UNITED STATES
DEPARTMENT OF THE INTERIOR
BUREAU OF LAND MANAGEMENT

SUNDRY NOTICES AND REPORTS ON WELLS
Do not use this form for proposals to drill or to re-enter an abandoned well. Use form 3160-3 (APD) for such proposals.

8. Well Name and No.
PERLA NEGRA FED COM 3H

XTO Energy Inc. requests a change to the planned BOP equipment used on this well. The original drilling plan submitted with the APD specified a 5,000 psi working pressure BOP system. We request to change this to a planned 3,000 psi BOP system. Maximum anticipated BHP should not exceed 5,050 psi (at 10,898' TD).

Choke Manifold Diagram
 XTO Energy, Inc..

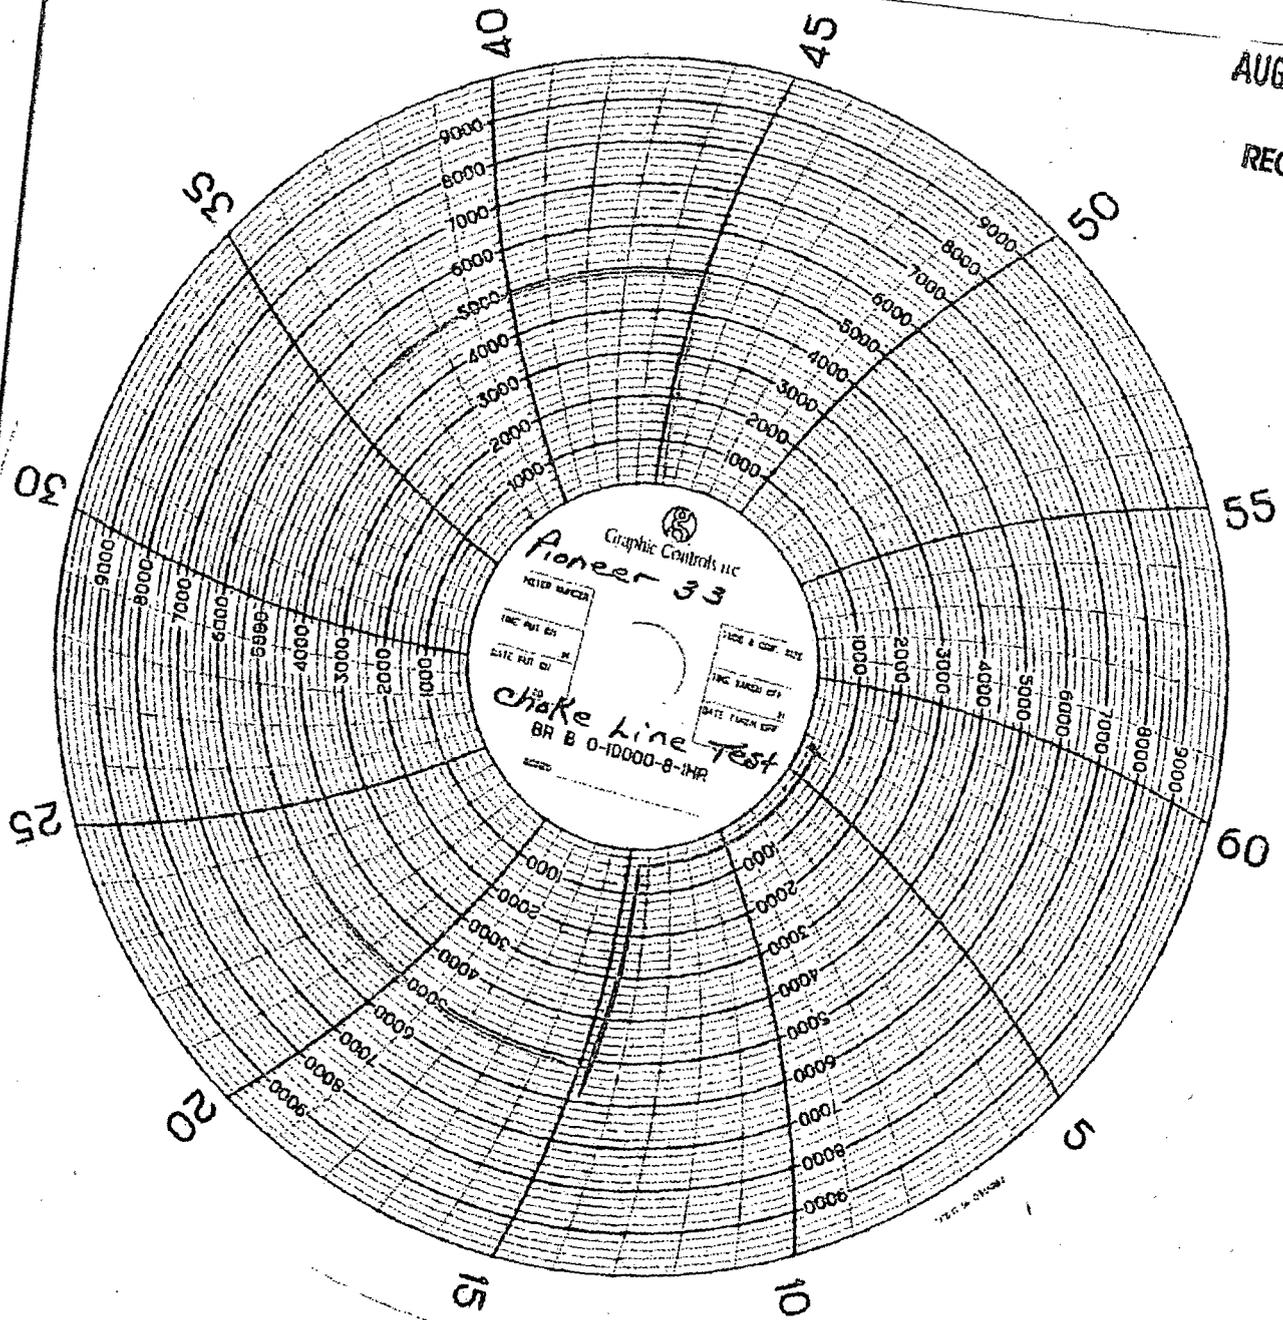
XTO is also requesting a variance to allow use of a flex hose as the choke line from the BOP to the Choke Manifold. If this hose is used, a copy of the manufacturer's certification and pressure test chart will be kept on the rig. Attached is an example of a certification and pressure test chart. The manufacturer does not require anchors.

2. Variance approved to use flex line from BOP to choke manifold. Check condition of flexible line from BOP to choke manifold, replace if exterior is damaged or if line fails test. Line to be as straight as possible with no hard bends and is to be anchored according to Manufacturer's requirements. The flexible hose can be exchanged with a hose of equal size and equal or greater pressure rating. **Anchor requirements, specification sheet and hydrostatic pressure test certification matching the hose in service, to be onsite for review. These documents shall be posted in the company man's trailer and on the rig floor.** If the BLM inspector questions the straightness of the hose, a BLM engineer will be contacted and will review in the field or via picture supplied by inspector to determine if changes are required (operator shall expect delays if this occurs).
